X3T13/96104r1

4 December 1995

ATA Overlap Proposal

This document presents the detailed text changes to the ATA-3 document (X3T10/2008Dr6) for the Overlap proposal. It is based on the Overlap proposal submitted by Western Digital Corporation (X3T10/95-258r0) with the changes presented by Quantum Corporation (X3T10/95-257r0).

Figure xx - Selection of device with pending interrupt

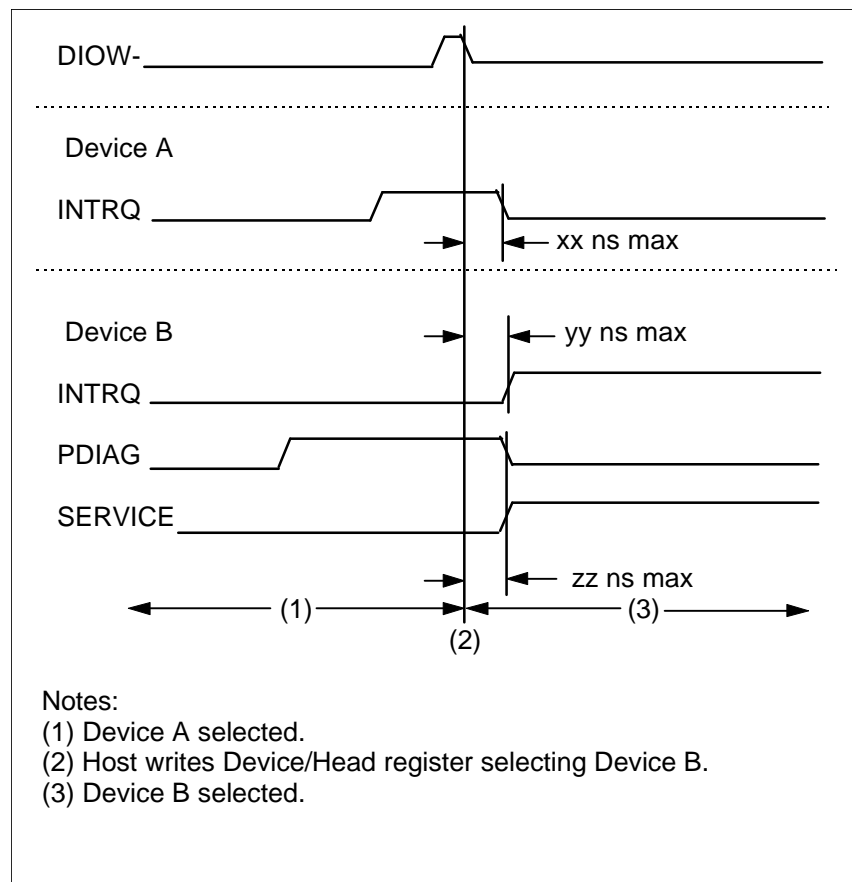
When the Device/Head register is written to select the device with the interrupt pending, the previously selected device shall cease asserting INTRQ within ns. The newly selected device shall set SERVICE, assert INTRQ and negate PDIAG no sooner than ns after the receipt of the SERVICE command but no later than ns. It is possible that the host will see INTRQ negate then reassert. See figure xx.

Figure yy Deselection of device with pending interrupt

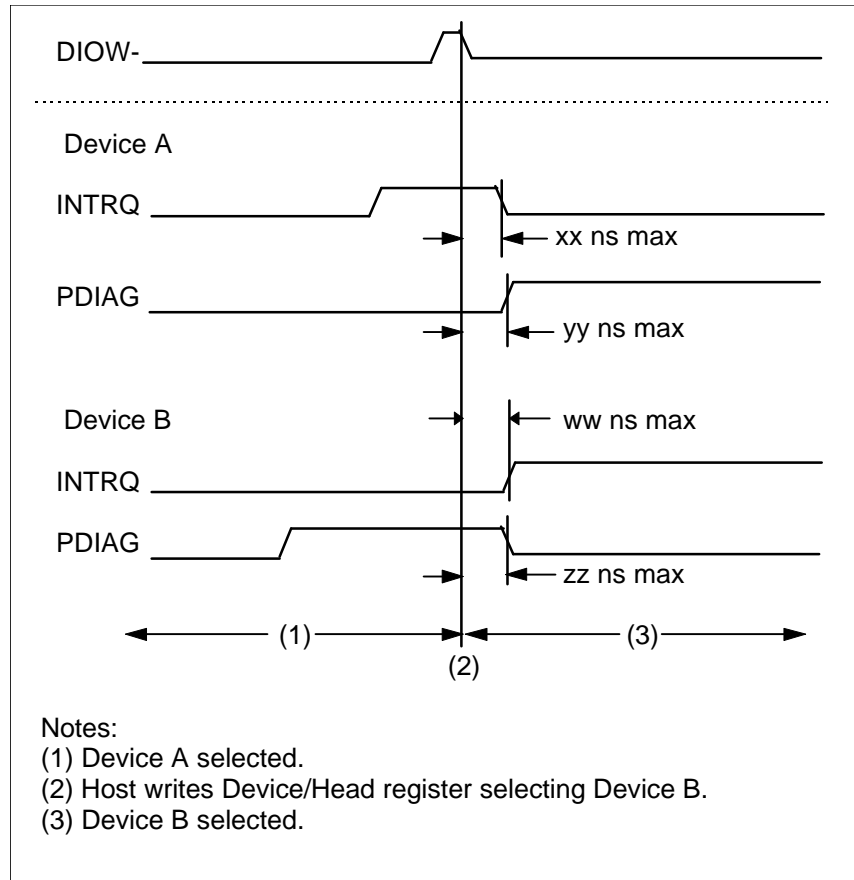
When a selected device has a pending interrupt and INTRQ asserted, if the other device is selected by writing to the Device/Head register, the device shall negate INTRQ within xxns and assert PDIAG- within yyns. If the newly selected device has an interrupt pending and was asserting PDIAG-, the newly selected device shall negate PDIAG- within zzns and assert INTRQ within wwns. See figure yy.

Figure zz - Proxy interrupt following selected device interrupt

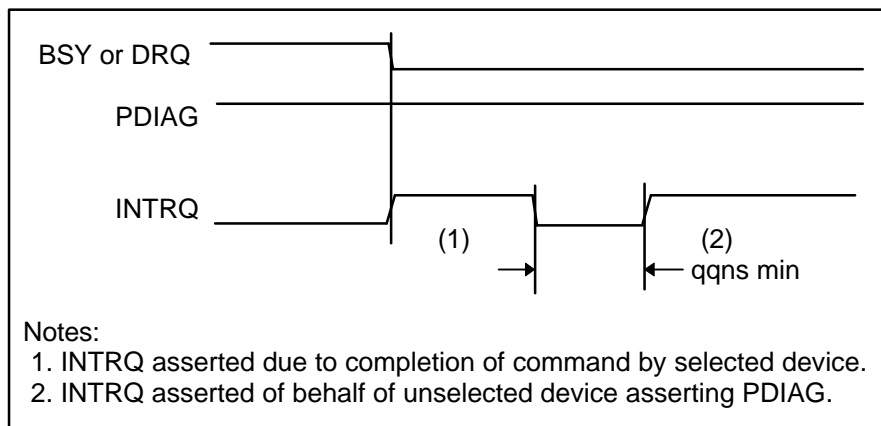
If a selected device is busy executing a command, i.e., BSY or DRQ set, when the unselected device asserts PDIAG, the selected device shall not assert INTRQ until it is no longer busy. When the selected device completes its command, it may assert INTRQ on its own behalf to indicate the command completion. In this case, the selected device shall not assert INTRQ on behalf of the unselected device until qqns after INTRQ has been negated when the selected device interrupt pending is cleared. See figure zz.

Figure aa - Command overlap and queuing state

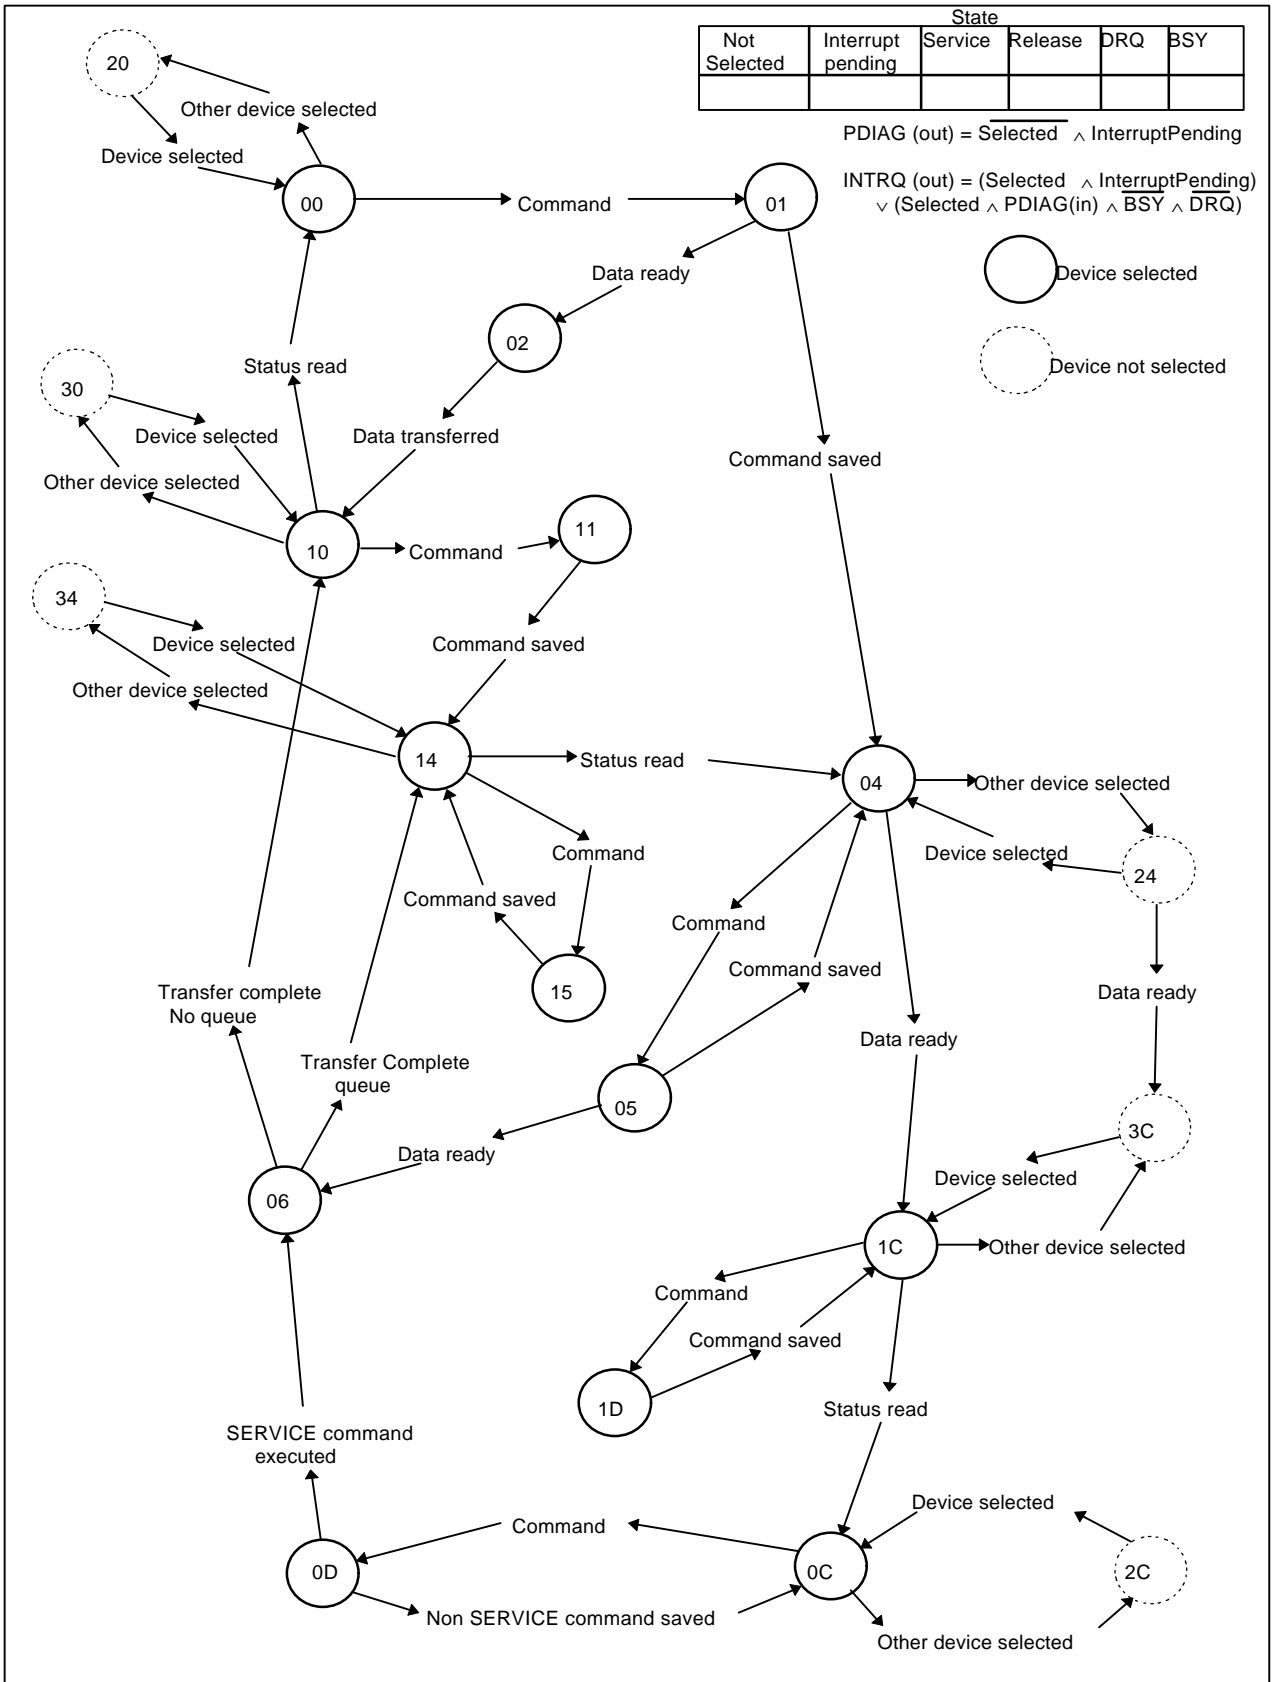
Revision D96104r1 - Added selected as a state bit in state and timing diagrams.

Figure aa is a state diagram for the protocol for command overlap and command queuing commands. Figure BB provides an example of commands overlapped to two devices. Figure cc provides an example of two commands queued to a single device.
